Southern California Edison Company, et al.; San Onofre Nuclear Generating Station, Units 2 and 3; Issuance of Director's Decision Under 10 CFR 2.206

Director's Decision Under 10 CFR 2.206

A. Request for an Investigation to Determine if SONGS Unit 2 Has Experienced Eggcrate Degradation Similar to Unit 3

B. Concern About the Seismic Adequacy of the SONGS Steam Generators

Figure 1

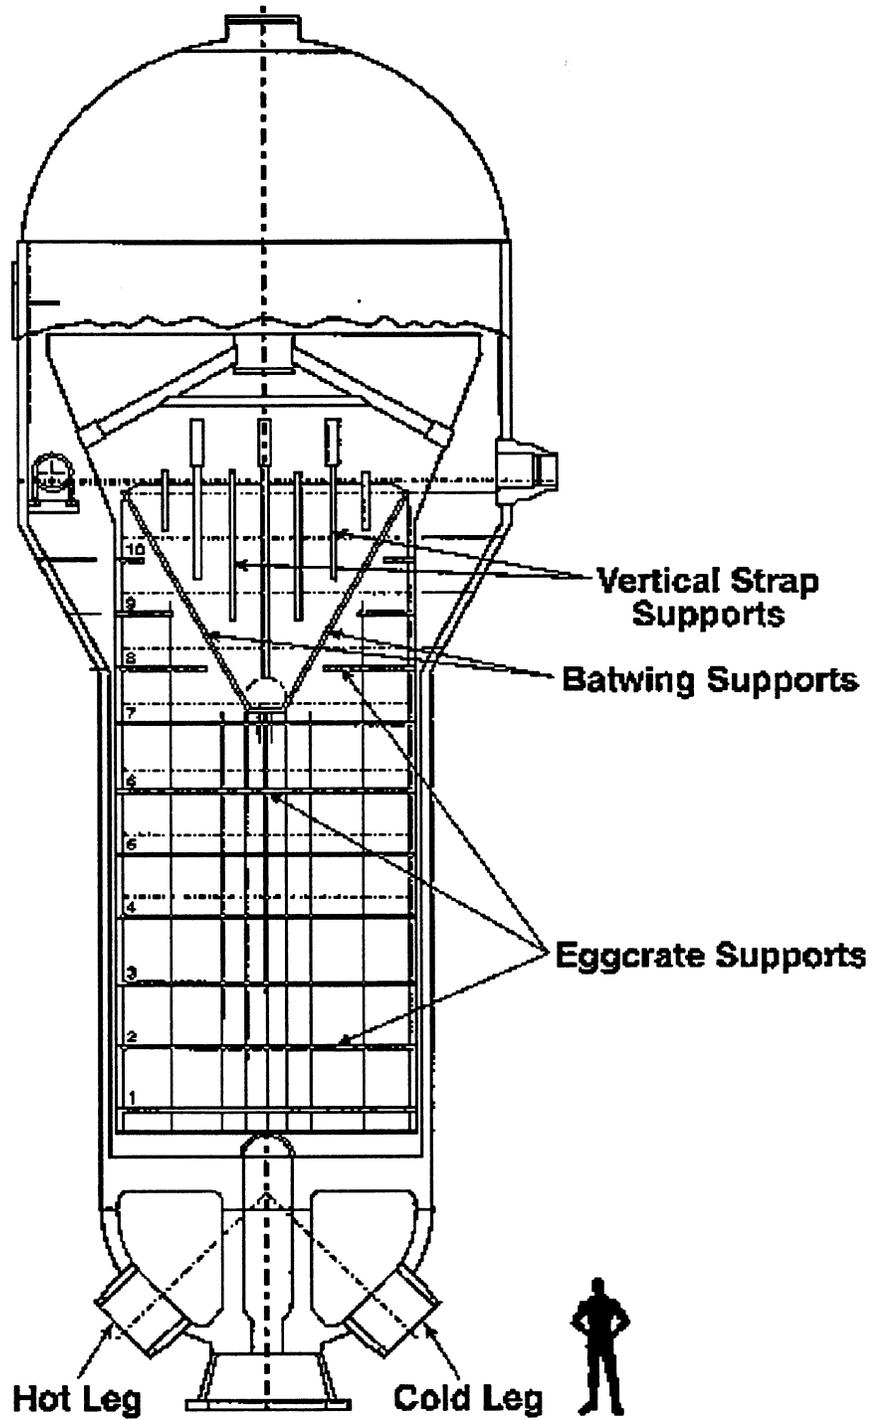
For the individual steam generator tube analysis, the licensee calculated the maximum loads that could occur assuming that adequate support was not available at two consecutive eggcrate levels (see Figure 1). The staff finds this assumption conservative and acceptable because the licensee has removed from service all tubes where two consecutive eggcrate levels were found degraded to the point where adequate support could not be assured.
